**REGIONAL WATER QUALITY
MANAGEMENT PLAN**

**TOWN OF BRISTOL
UTILITY DISTRICT NO. 1**

RESPONSE TO REQUEST BY THE TOWN OF BRISTOL TO AMEND THE TOWN OF BRISTOL UTILITY DISTRICT NO. 1 SANITARY SEWER SERVICE AREA

PROPOSED AMENDMENT TO THE TOWN OF BRISTOL UTILITY DISTRICT NO. 1 SANITARY SEWER SERVICE AREA

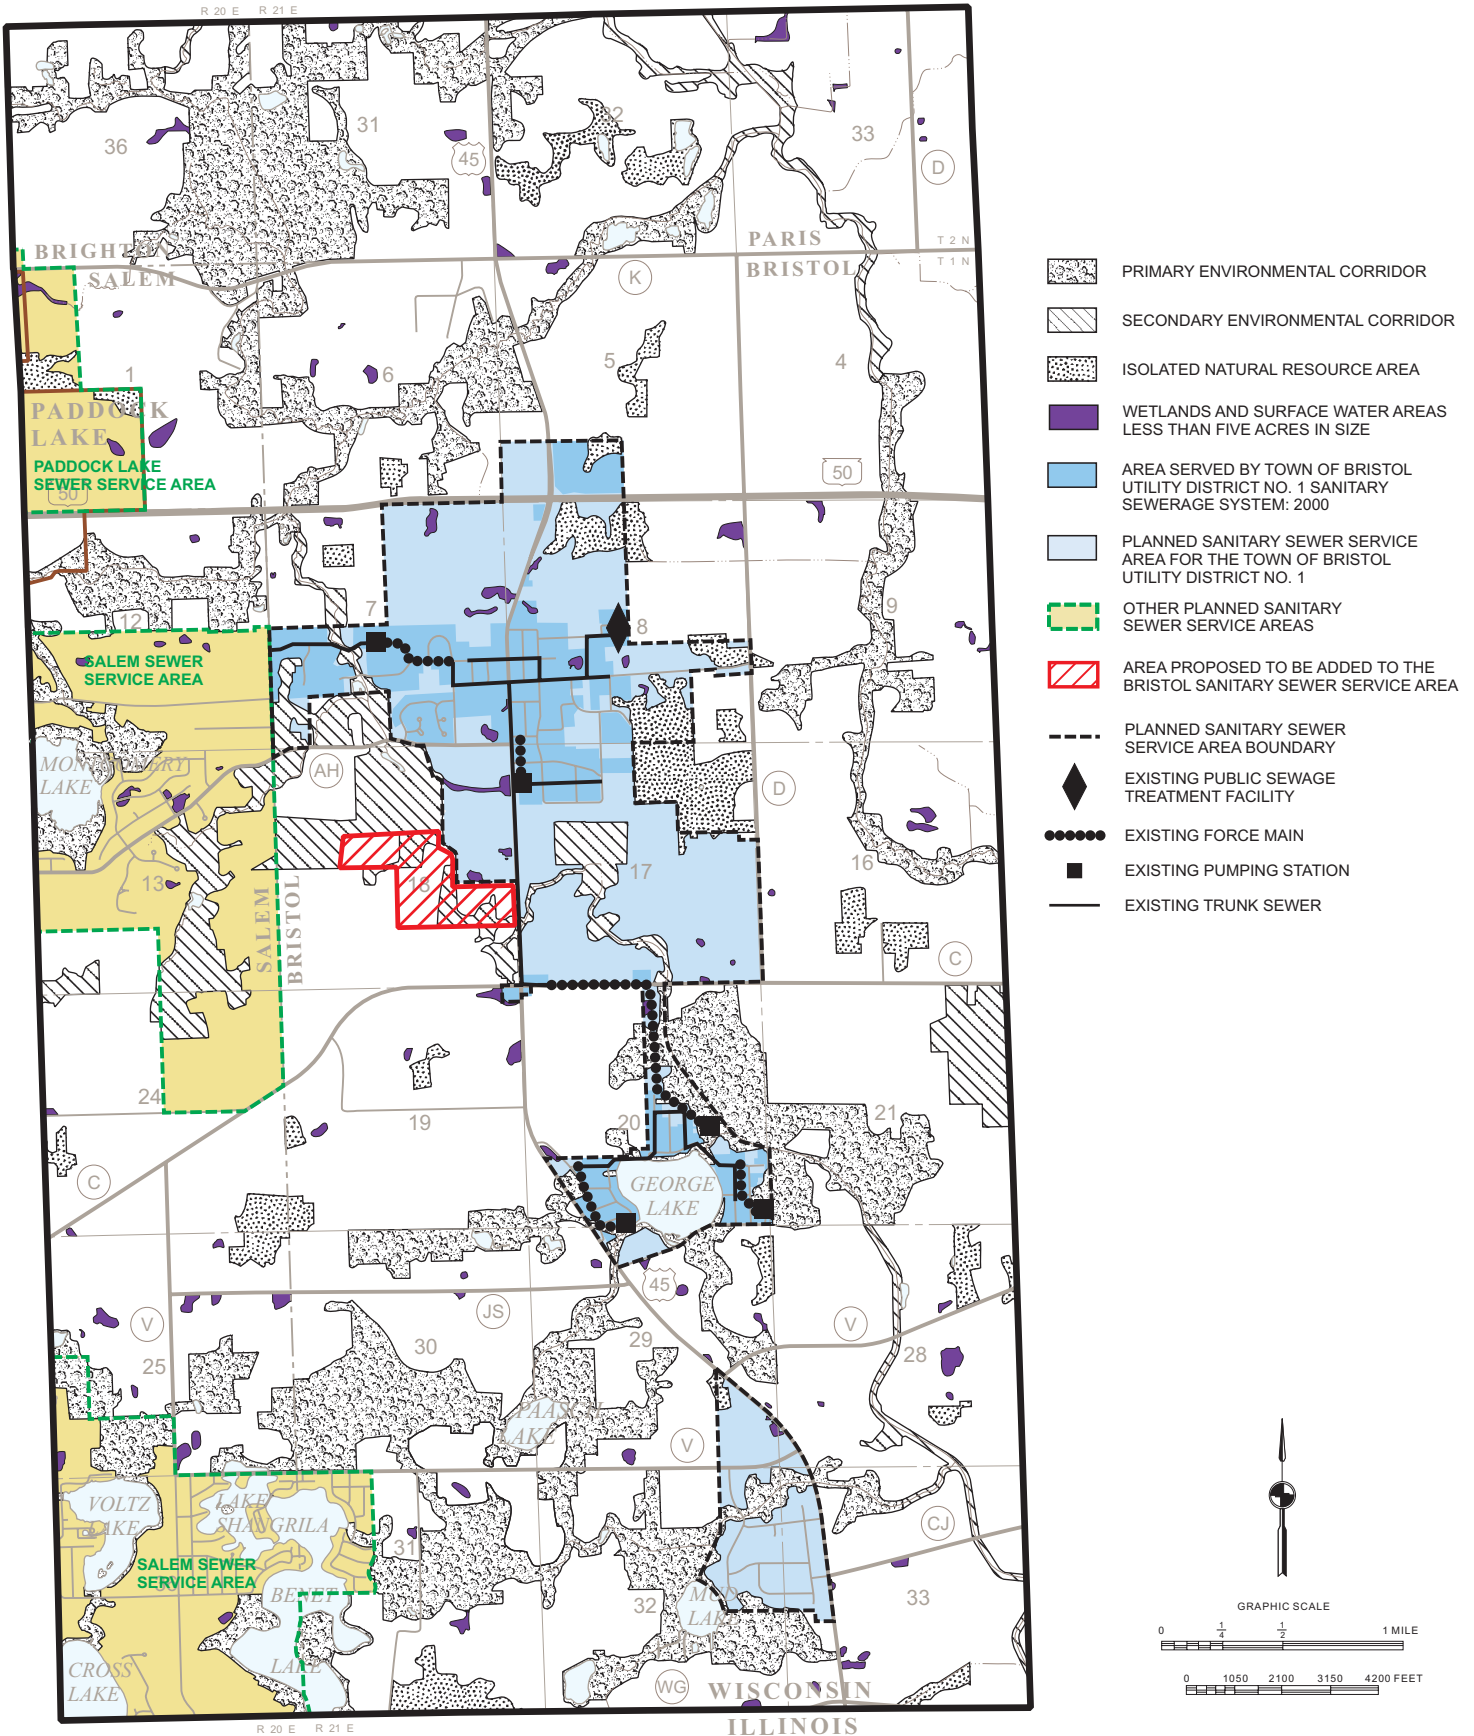
The area proposed to be added to the Bristol UD1 sanitary sewer service area encompasses 109 acres located in U.S. Public Land Survey Section 18, Township 1 North, Range 21 East, in the Town of Bristol (see Map 1). The subject area contains 35 acres of environmentally significant lands, all classified as secondary environmental corridor. The subject area does not contain any existing urban land use, except for 1 acre of road right-of-way. A preliminary development plan indicates that the subject area would accommodate about 60 single-family dwellings with an estimated population of about 150 persons. This would be part of proposed residential development project that includes certain lands already within the adopted sewer service area.

The proposed addition of 109 acres to the Bristol UD1 sanitary sewer service area represents an increase in the planned sewer service area of 5 percent. Including the potential population of the area proposed to be added to the sewer service area at this time, the buildout population of the sewer service area—that is, the estimated population which could be accommodated upon full development of the sewer service area—would approximate 4,500 persons. That is within the range of projected population of 4,100 to 7,100 persons for the Bristol area under the year 2035 regional land use plan.

Based on the foregoing, it is recommended that the Southeastern Wisconsin Regional Planning Commission formally amend the sanitary sewer service area for the Town of Bristol Utility District No. 1 as documented in SEWRPC Community Assistance Planning Report No. 145, as amended, in the manner identified on Map 1.
